ADDENDUM NUMBER 04

**PROJECT: LAUDERDALE COUNTY INNOVATION CENTER
GMC PROJECT NO. ABHM210017**

ADDENDUM #04

Bernhard TME Project No. 12-22-0082
Client Project No. ABHM210017

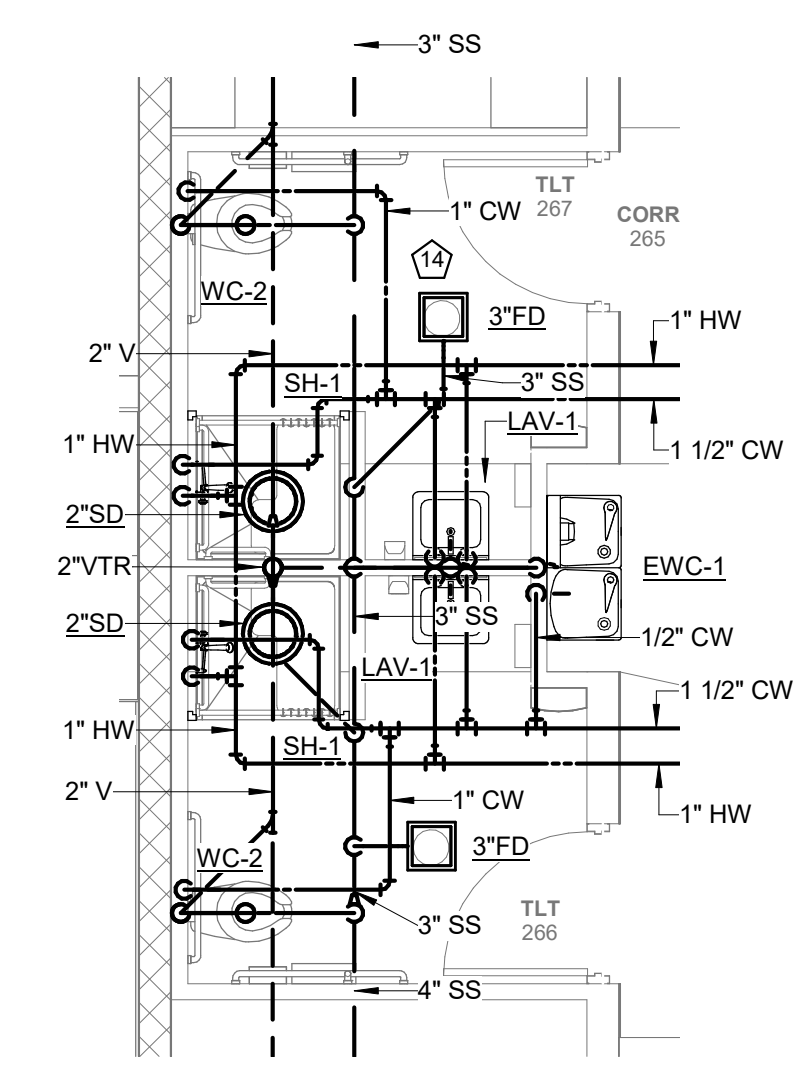
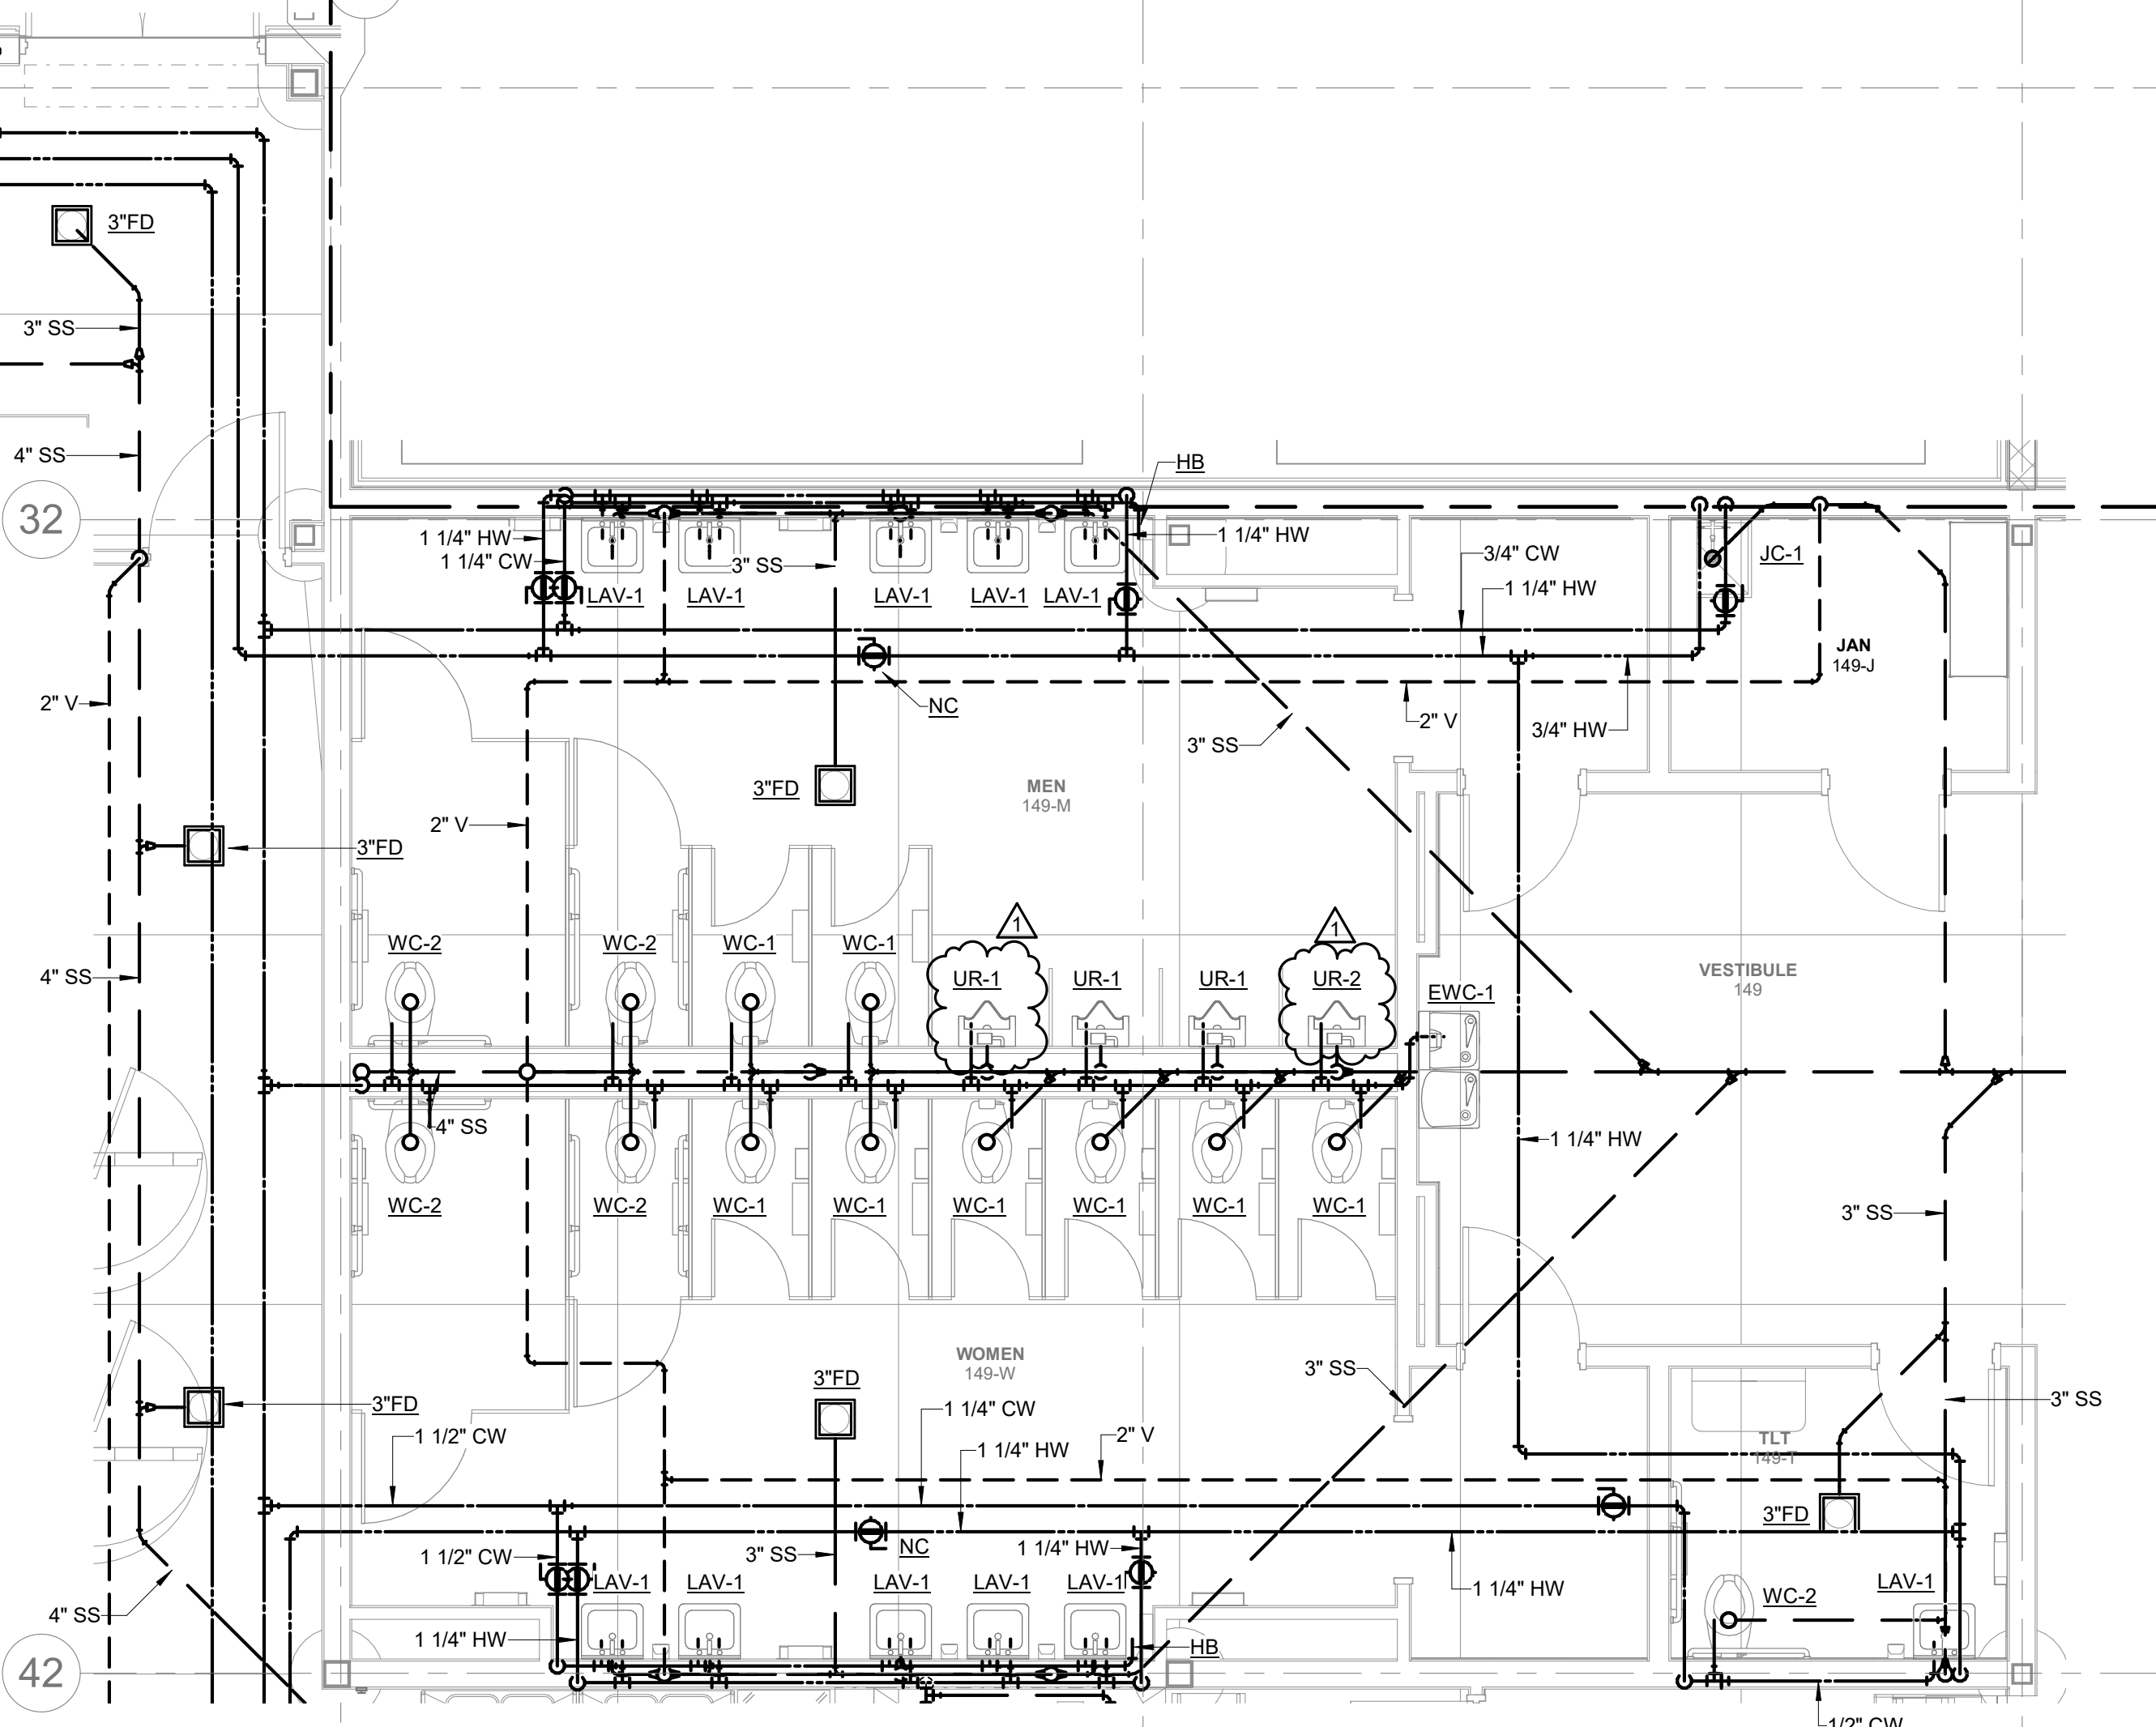
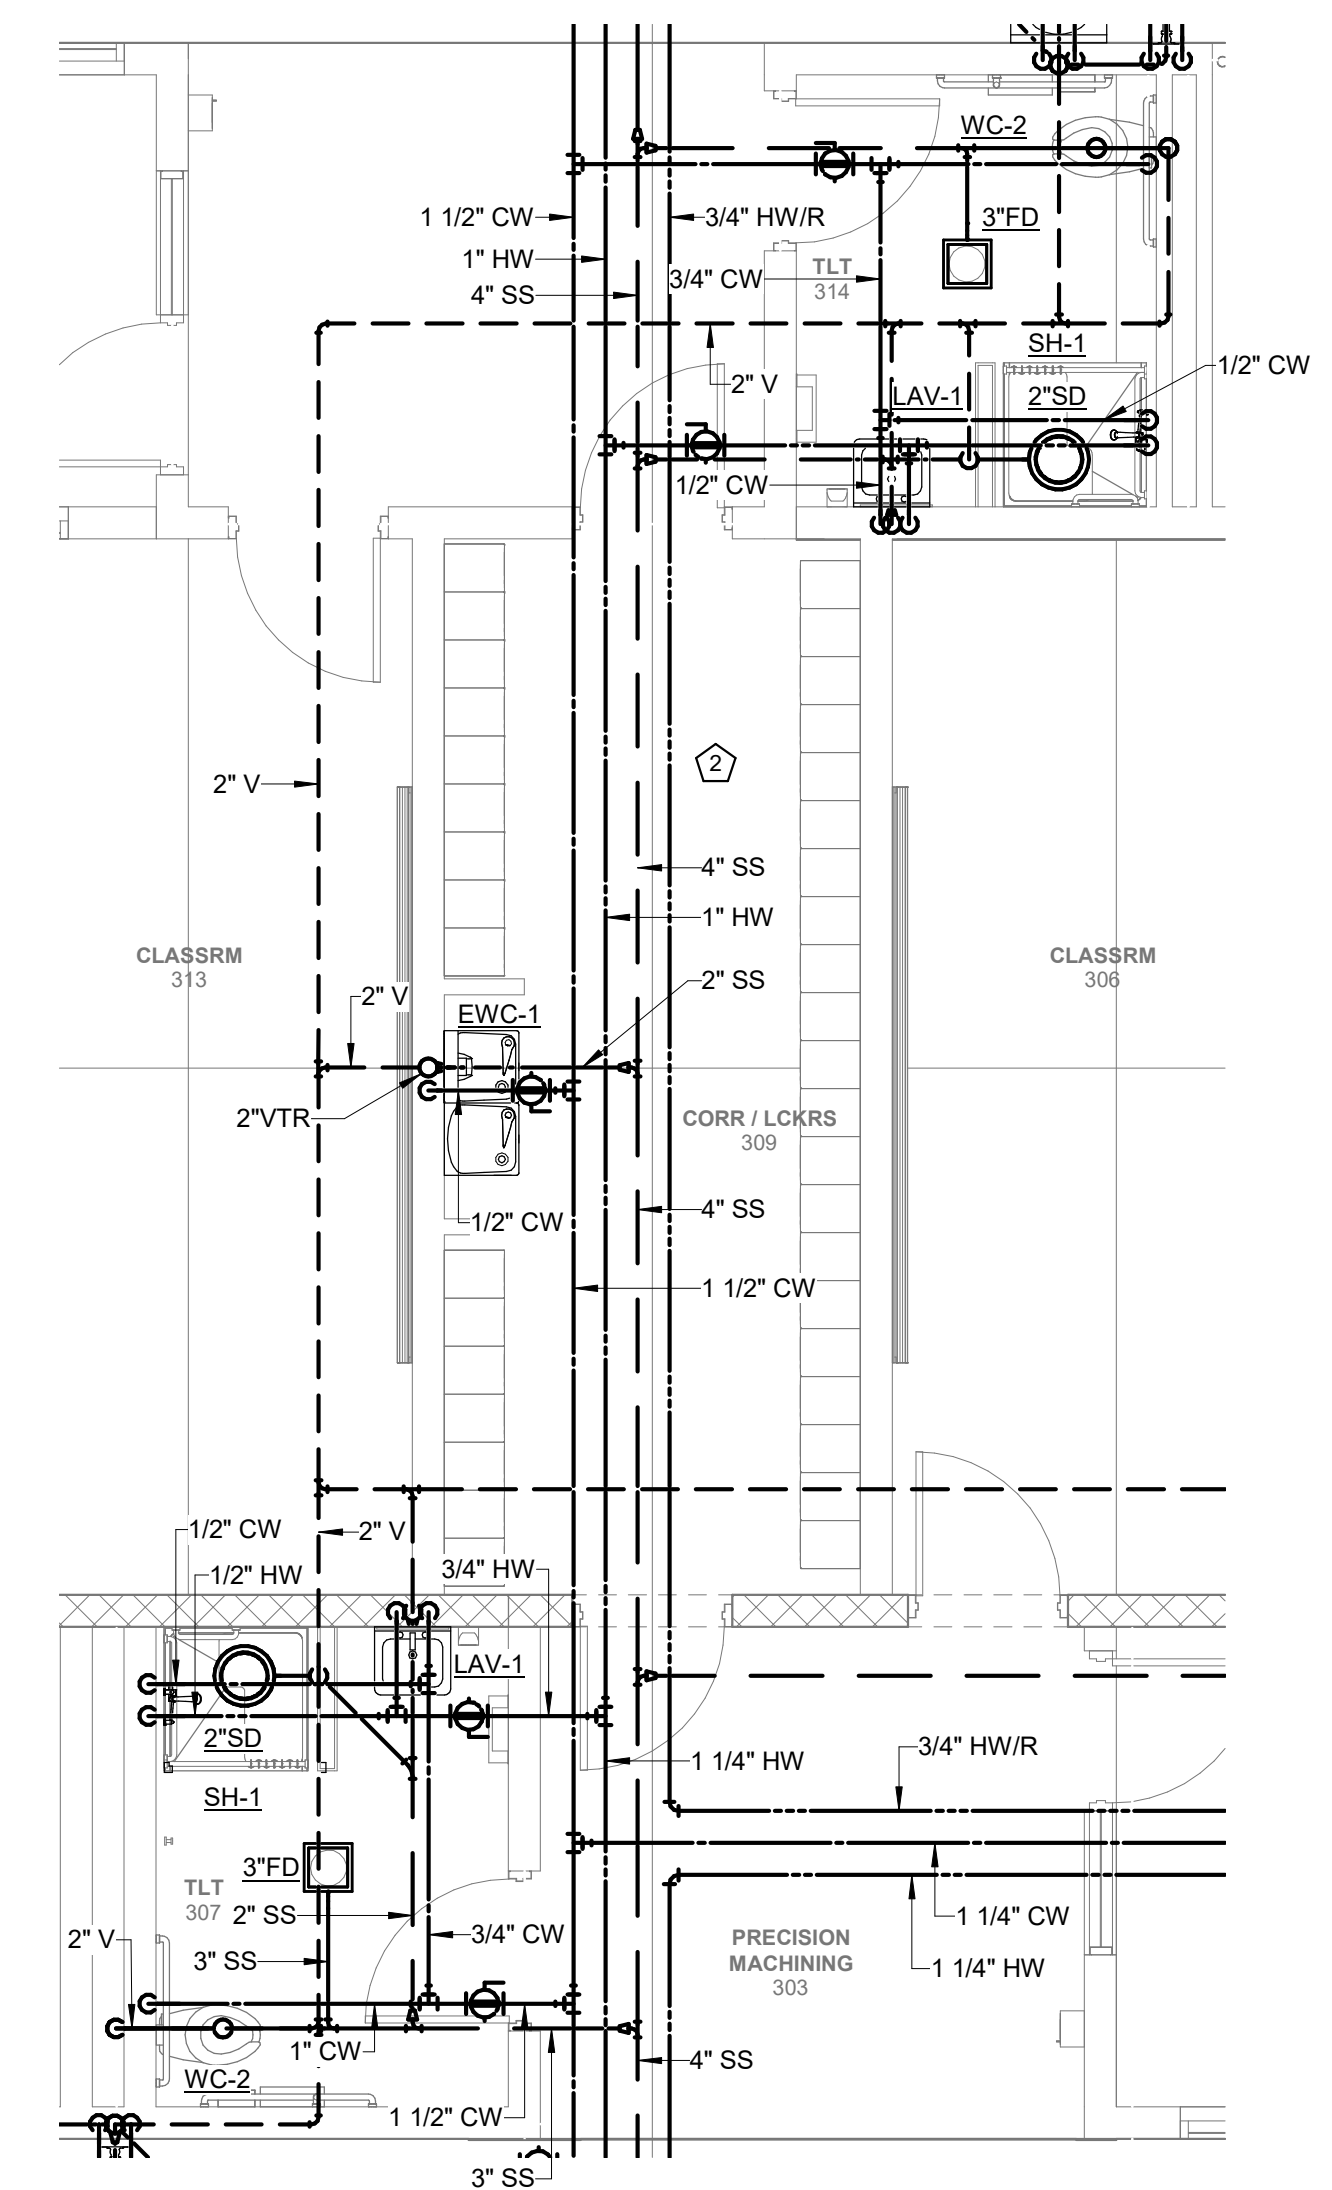
6. Refer to Revised Sheet (P2.07) – (PARTIAL FLOOR PLANS – PLUMBING PIPING) – revision dated (2023-11-03):
 - A. **REVISE** ADA urinal locations.
